TECH EXCHANGE

SUBJECT: 2015 ~ 2021 YZF-R1 and YZF-R1M — Oil Strainer Cover Supersession

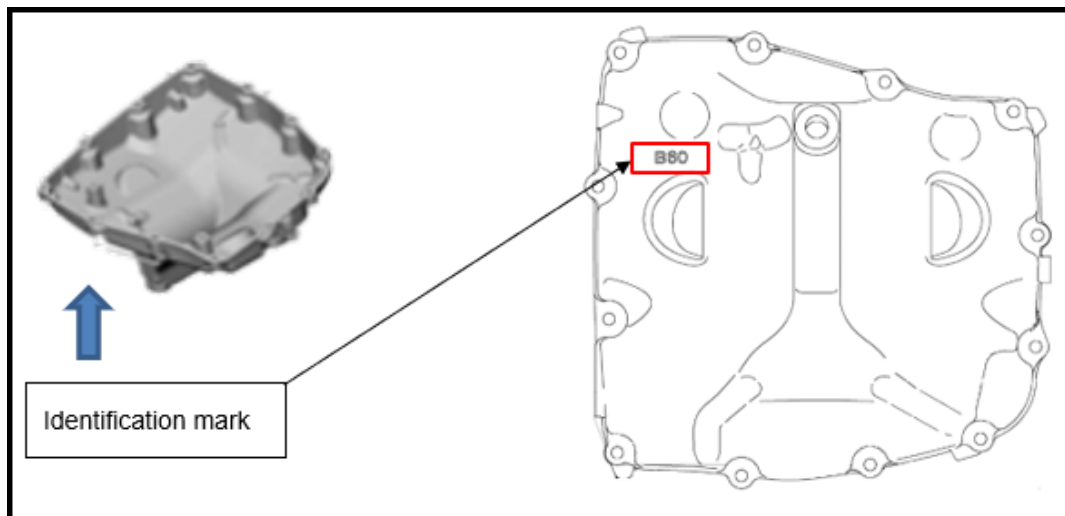
The magnesium oil strainer cover has “2CR” printed on the surface.

The aluminum oil strainer cover has “B60” printed on the surface.

Due to the superseded kit parts being an aluminum oil strainer cover with steel bolts and steel oil strainer cover gasket, all 12 bolts will require Loctite® and be torqued to 10 Nm (1.0 kgf-m, 7.4 lb-ft).
